Type FT-01
Typical Office Facade: East & West

1 Denison Street
Sydney, New South Wales,
Australia
TD1
Tower Facade Type FT-01 - Typical
East & West Vision Glass

PROPOSED DESIGN

Drawing no. **A10.100**
Revision **3**

Tower Facade Type FT-01 - Typical
East & West Vision Glass

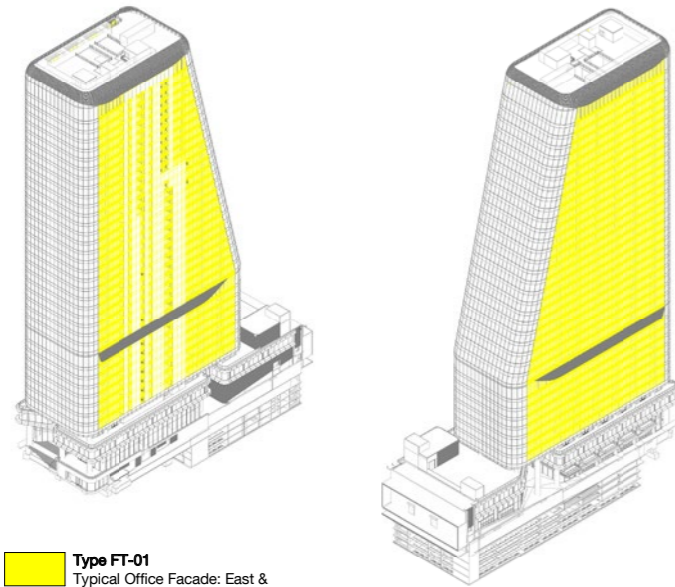
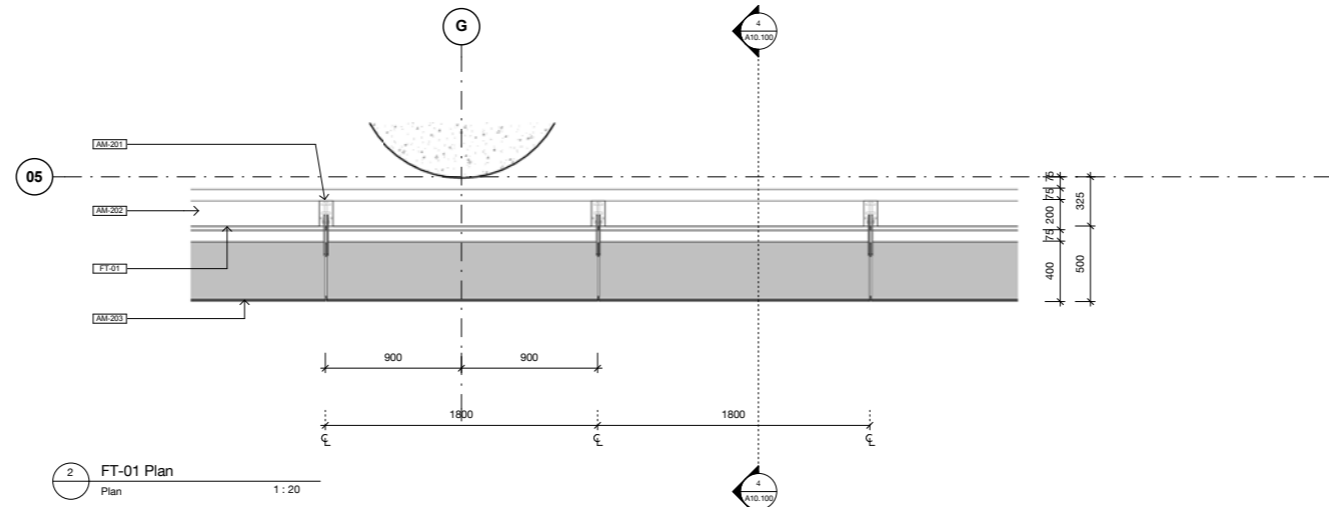
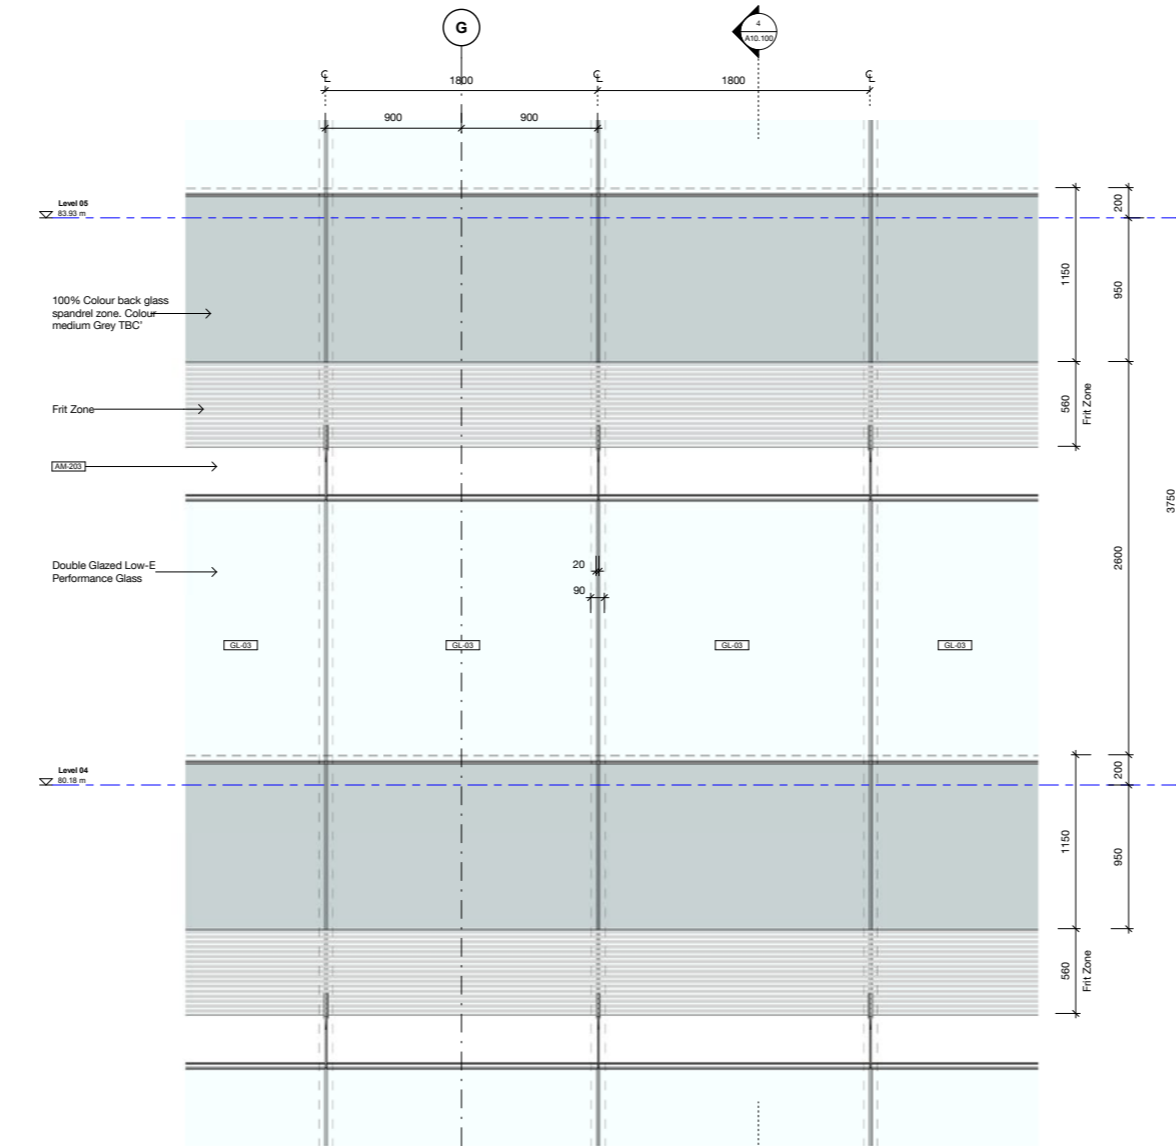
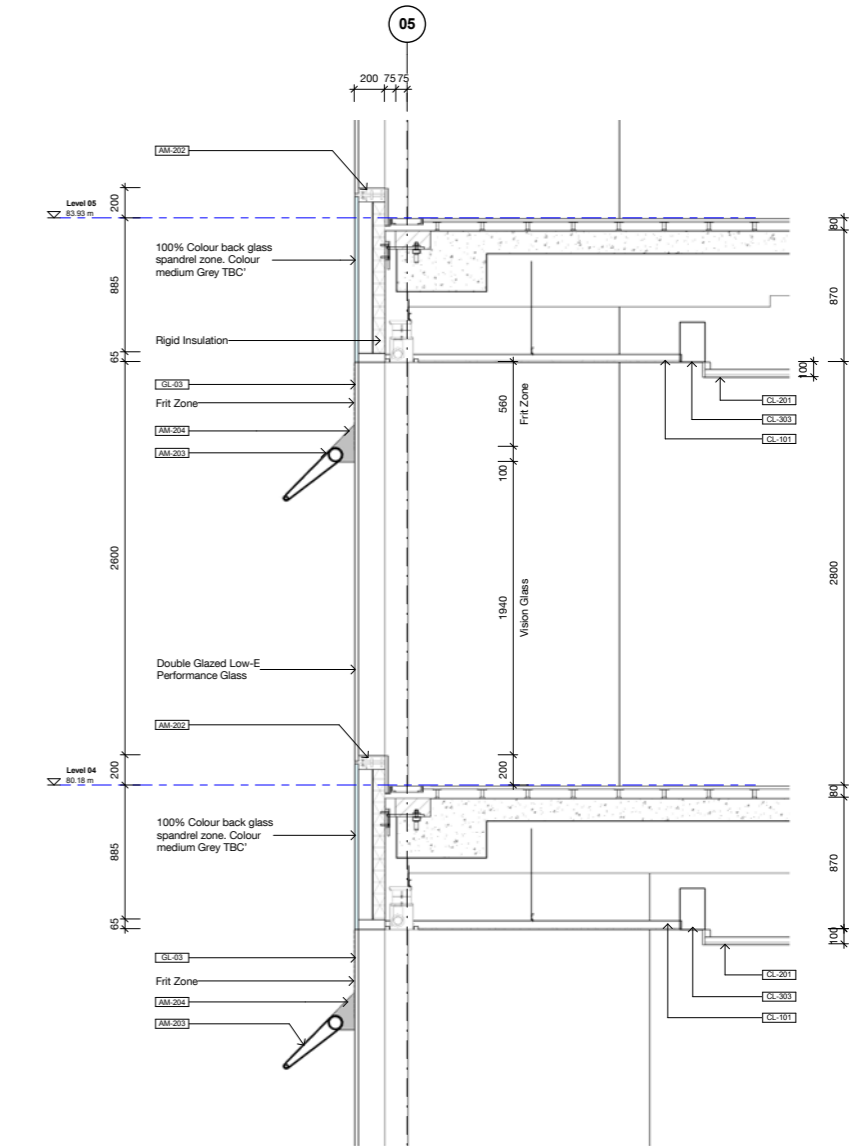
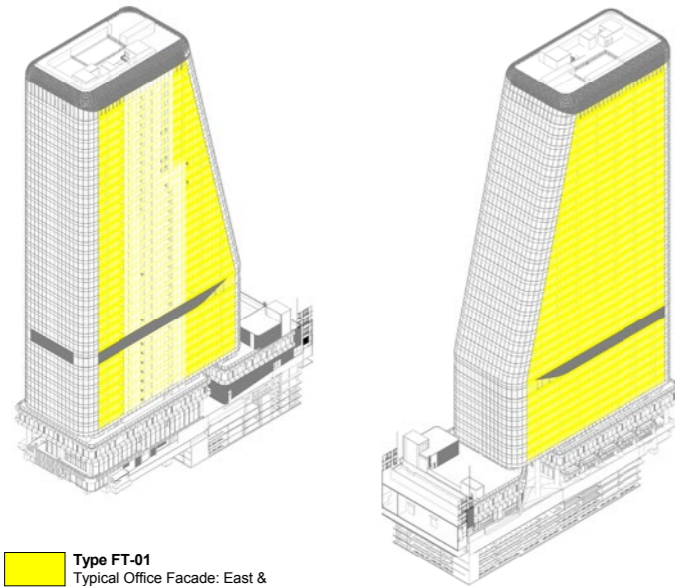
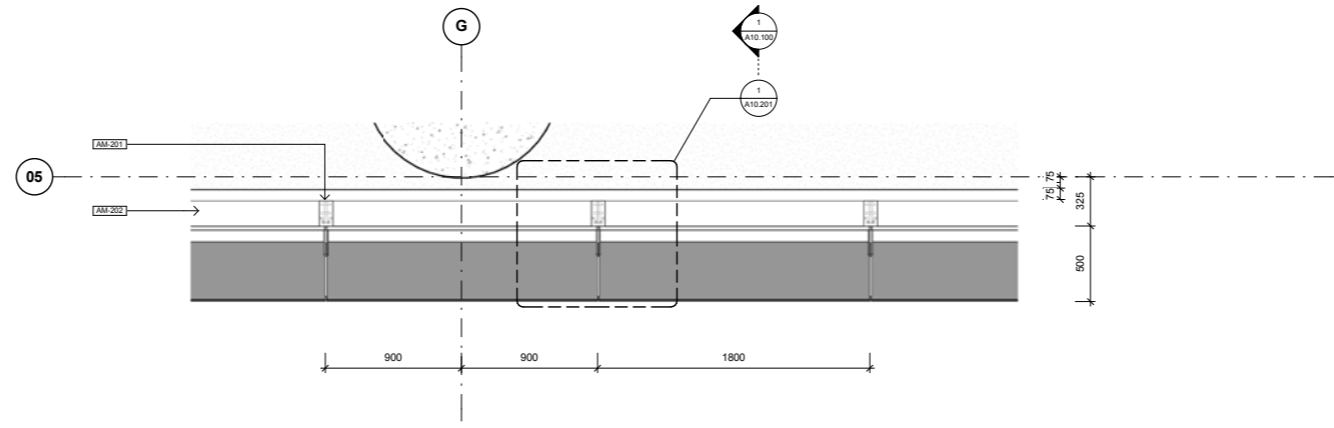
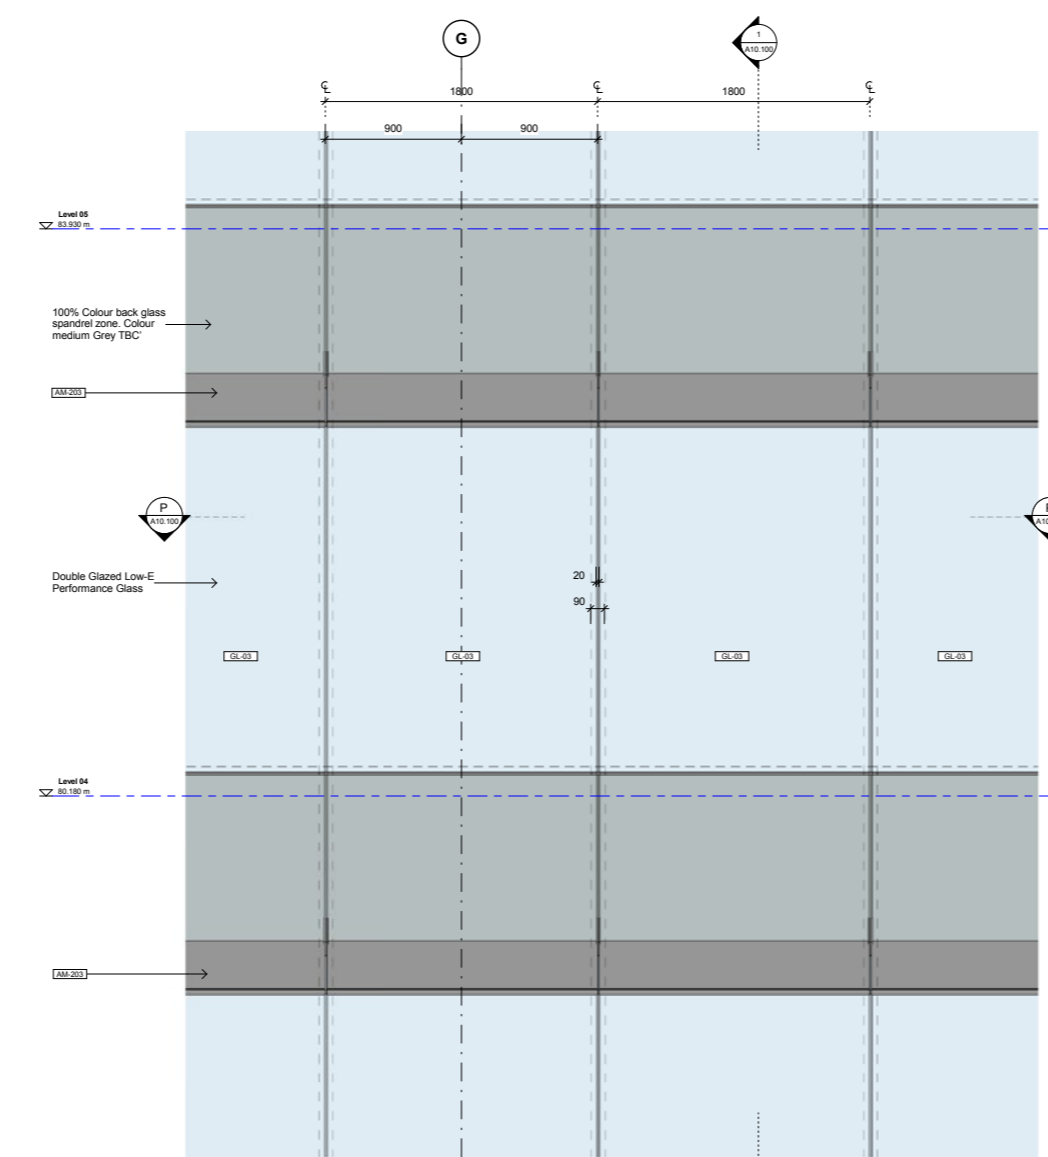
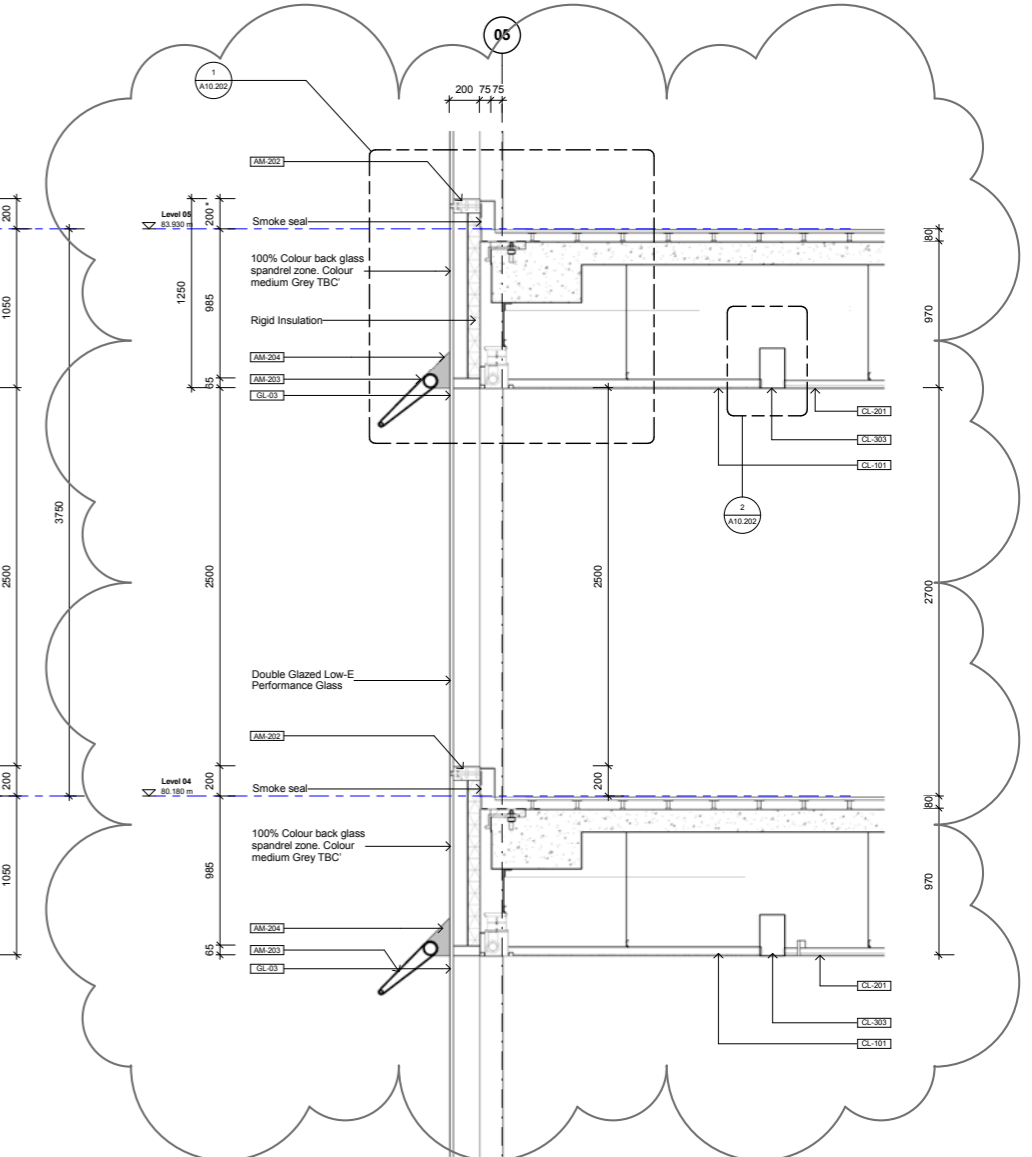
- Notes - Facade:**
- 200mm Upstand to be amended to 300mm to achieve required facade performance. Refer to details A10.200 series.
 - All dimensions are indicative. Contractor and fabricators to verify all dimensions prior to construction.
 - Refer to A20.000 for Master Schedule code reference descriptions.
 - Refer to A10.200 series for Tower facade details.
 - Refer to A10.400 & A10.600 series for Podium facade types & details.
 - Refer to Structural, Mechanical, Electrical, Lighting, Hydraulic and Fire services documents.
 - Allow for all requirements as outlined in Acoustic, Accessibility, BCA, ESD (BASIX / Part J or similar) and Fire Engineering reports.
